# COMMUNITY DEVELOPMENT DEPARTMENT REPORT

SUBJECT: H-2024-0067  
Mondt Meadows Subdivision AZ,  
CPAM, PP

LOCATION: 6101 and 6162 S. Tarrega Lane, located  
in the SE ¼ of the SW ¼ of Section 31,  
T.3N, R.1E, Parcels S1131346650 and  
S1131346605

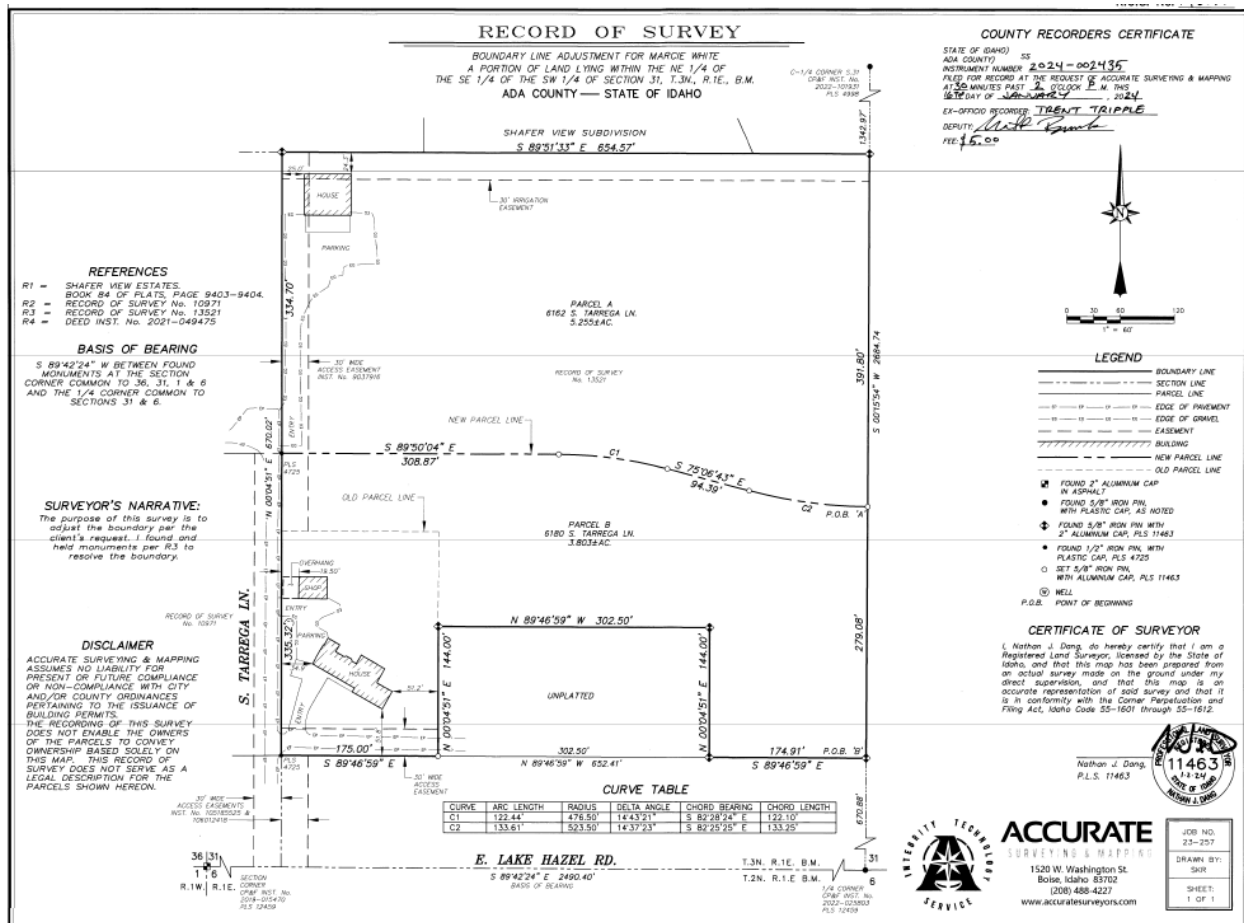
The property resides within Ada County and is currently zoned RUT. The property owner recorded a property boundary adjustment on January 16, 2024, to reconfigure the lot lines in order to subdivide the norther half of their property. See Record of Survey below.

There are existing easements on the property that are being proposed to be relinquished.

- There is a thirty (30) foot wide access easement (Instrument No. 7520424 & 2021-049475), that runs across the north boundary of both parcels in the project, as well as the west thirty (30) feet of each parcel. These easements are no longer required and will be relinquished with the recordation of the final plat.
- The existing thirty (30) foot wide access easement, (Instrument No. 9037915), which runs across the east 302.15' of the south boundary of parcel S1131346650 will be relinquished with the recordation of the final plat due to the public road improvements in the same location.
- Dry ditch that runs through parcel S1131346650 along the east side needs to be either depicted on the plat map within an easement or provide written documentation showing the dry ditch had been abandoned and is no longer in use by the affected property owners.

## D. Preliminary Plat (date: 4/7/2025)

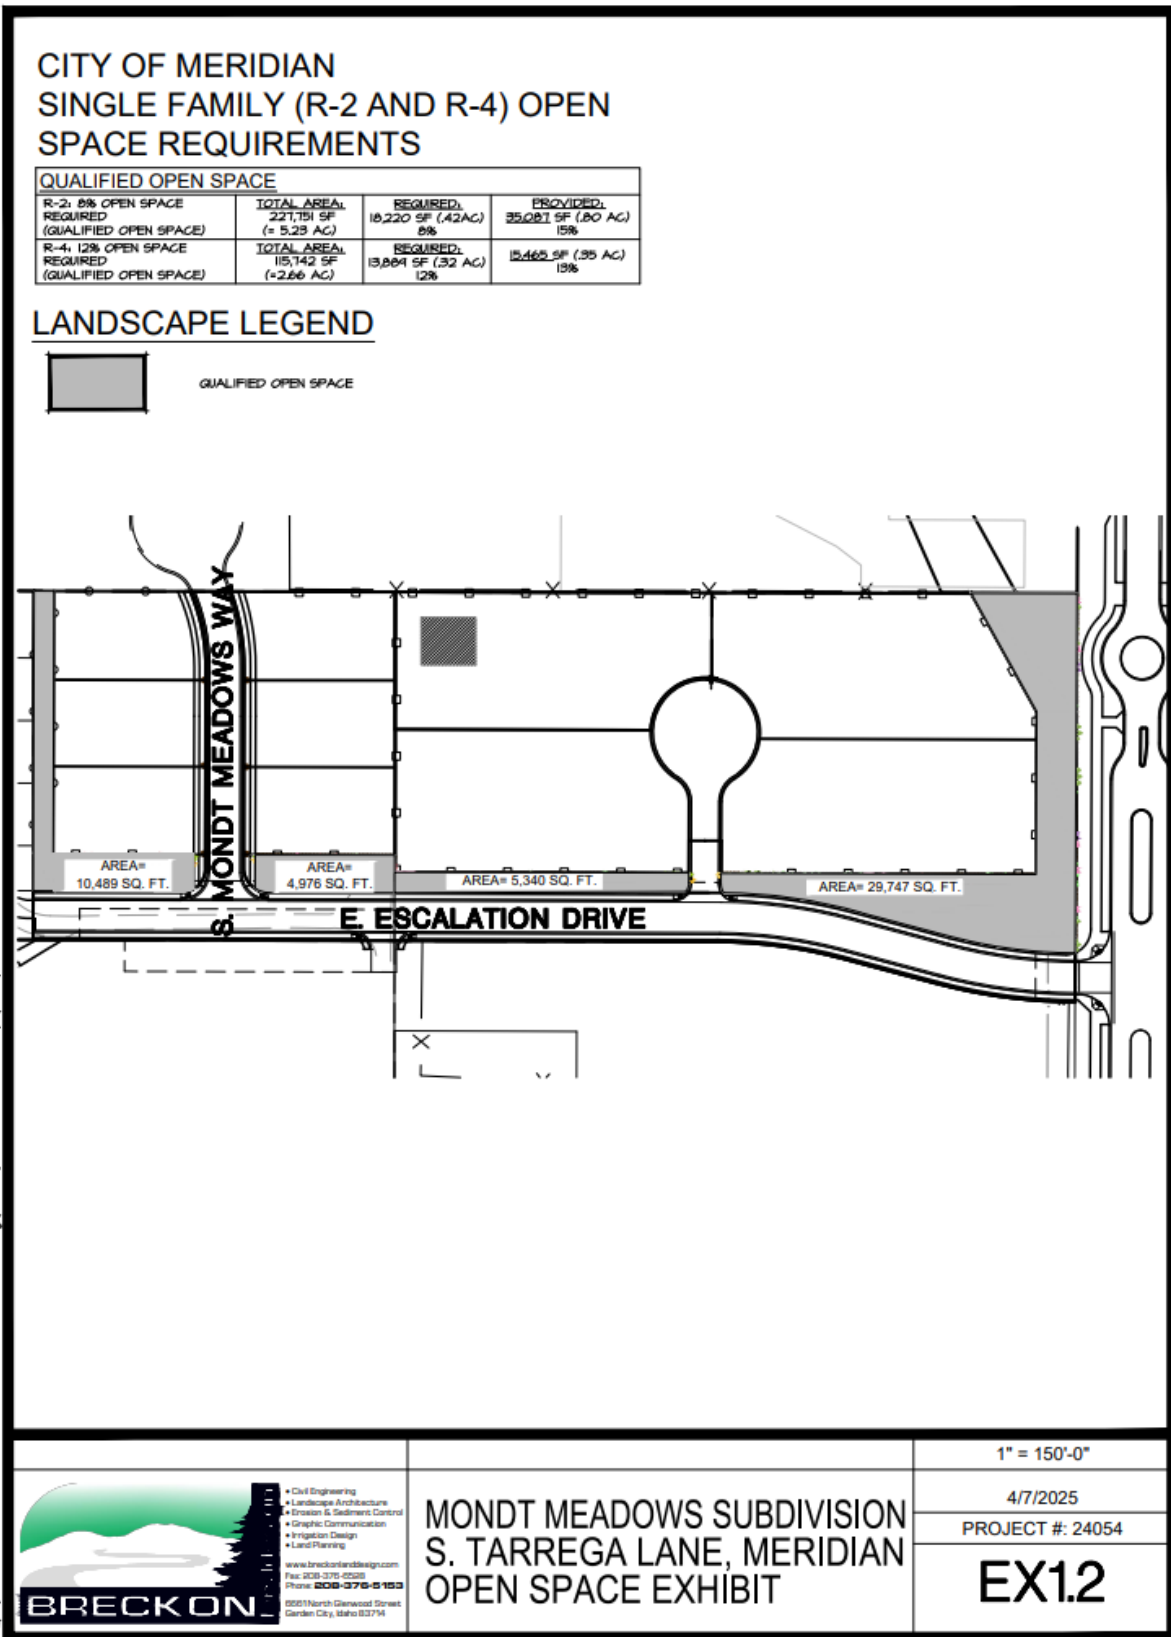
- 2. Submit the following revisions for the Preliminary Plat included in Section VII, dated 4/7/25:
  - a. Revise the plat map to depict the dry ditch on parcel # S1131346650 and its associated easement or provide written documentation showing the dry ditch had been abandoned and is no longer in use by the affected property owners.

- b. Lots shall meet the dimensional requirements of the R-2 and R-4 zoning districts per UDC 11-2A-4 and UDC 11-2A-5.
- 3. The Landscape Plan included in Section VII, dated 4/7/25, shall be submitted for review and approval with the following revisions prior to final plat approval:
